Duquesne Light Company

Reference: Beaver Valley Power Station, Unit No. 1
Docket No. 50-334, License No. DPR-66
Response to R. G. 1.97

This letter is in response to the request for additional information (RAI) on the Regulatory Guide 1.97 (R.G. 1.97) variable for steam generator wide range (SGWR) level instrumentation. The RAI was by telecon with the Region 1 and NRR Staff on March 8, 1990.

Steam Generator Wide Range Level Instrumentation

FIGURE 1

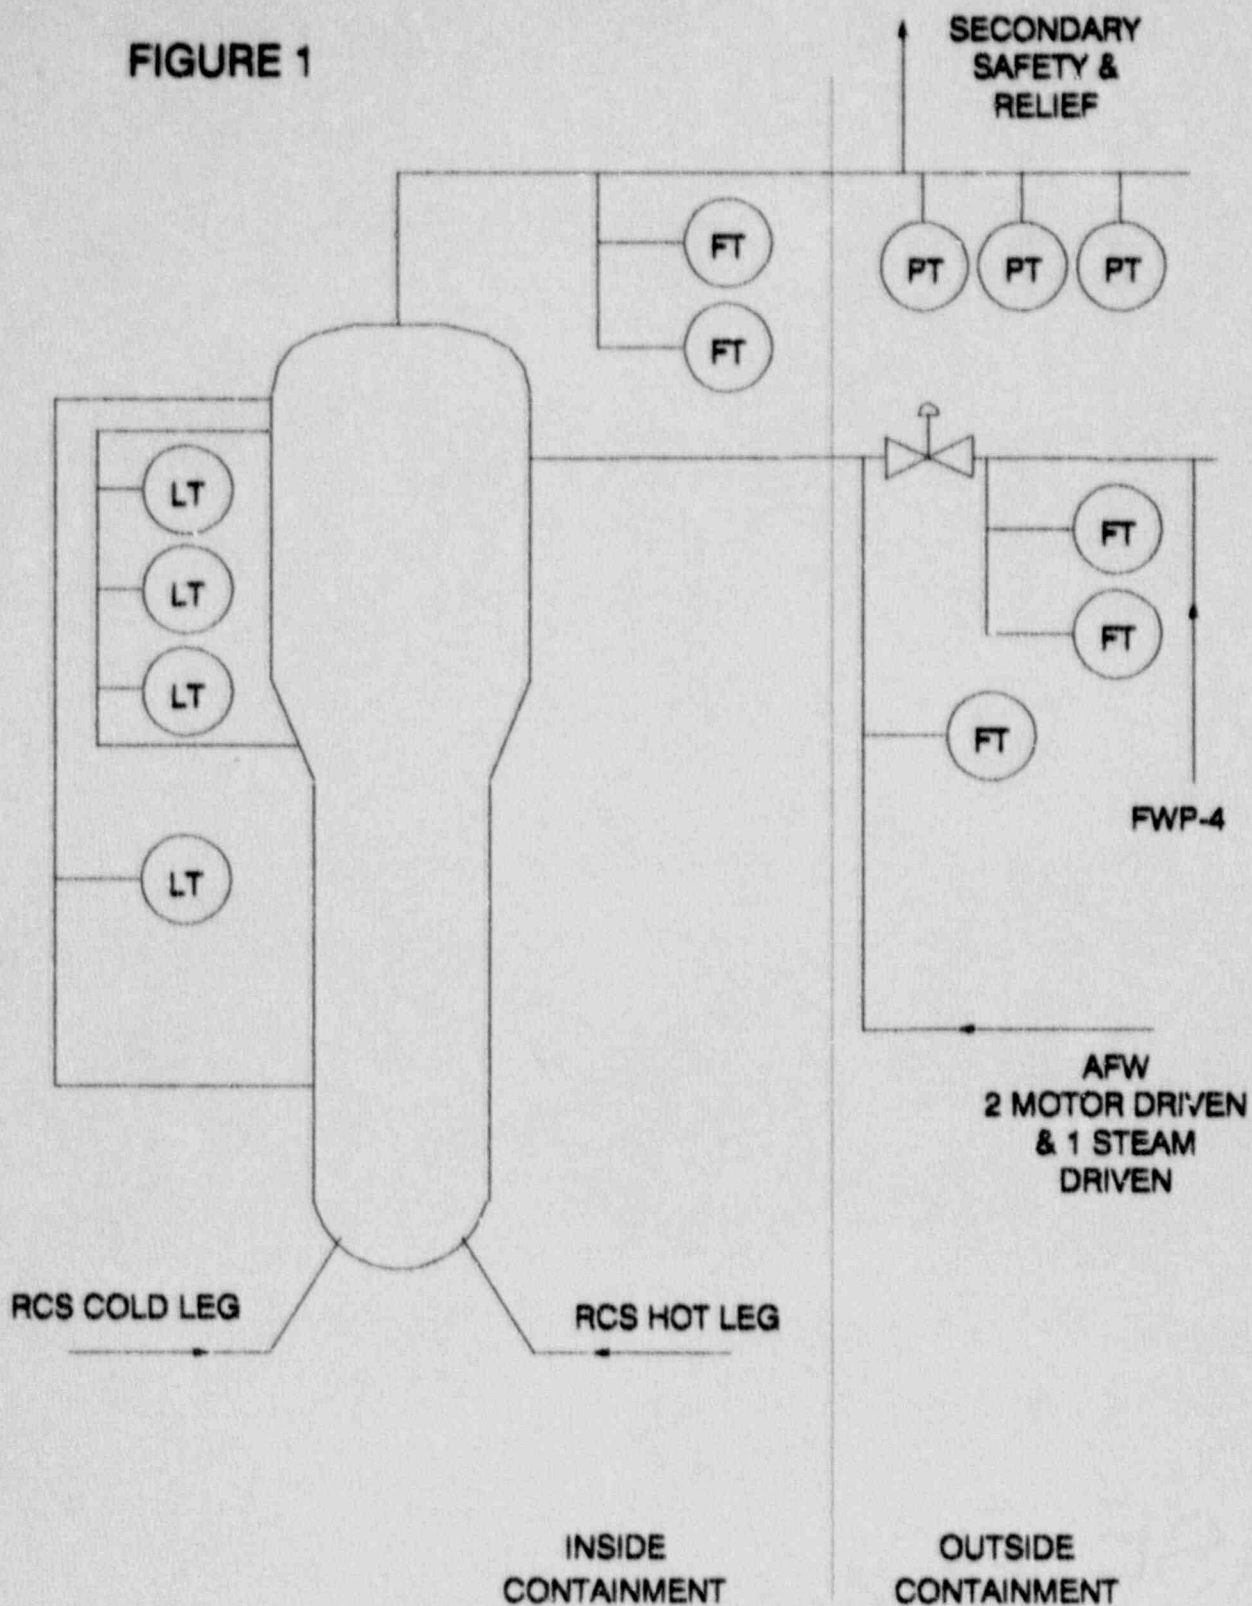
The three wide range steam generator level channels are indicated and recorded on a single recorder. A failure of the power supply to the recorder would result in a loss of three wide range level indications.

The three wide range level channels are powered from separate vital busses but are routed together in neutral cable trays from the sensors to the indicating and recording device. No isolation devices are installed. Regulatory Guide 1.97 describes steam generator level as a DI variable.

The Duquesne Light Company (DLC) submittal of December 18, 1989 discusses alternative and diverse instrumentation. A more detailed discussion of these parameters and the combination of parameters as they relate back to steam generator level (i.e. heat sink availability) is requested for NRC review. Additional information on the associated flowpaths through the Emergency Operating Procedure (EOPs) is also requested.

Figure 1 of this attachment is a graphical view of the instrumentation provided for each steam generator. The figure can act as a reference for the discussions which follow. As can be seen on the figure, there are the following instrumentation channels which have indication in the control room. Please refer to Table 1 of our submittal of December 18, 1989 for additional information on the auxiliary feedwater flow and the WR and NR level instrumentation.

- Auxiliary Feedwater (AFW) - There is one (1) flow transmitter for each steam generator in the line supplied by the two motor driven and one steam driven AFW pumps. The flow from the fourth AFW pump, FWP-4, can be detected by two flow transmitters in the normal feedwater supply line.
- Steam Generator Steam Flow and Pressure - There are two flow transmitters and three pressure transmitters for each steam generator. The flow instrumentation is located upstream of the safety and relief valves as shown on the figure and the pressure transmitters are upstream of the main steam isolation valves.
- Level Transmitters - The approximate arrangement of the one WR level and three NR level transmitters are shown on the figure.
- Also, not shown on the figure, radiation monitoring is provided for the air ejector and blowdown lines.
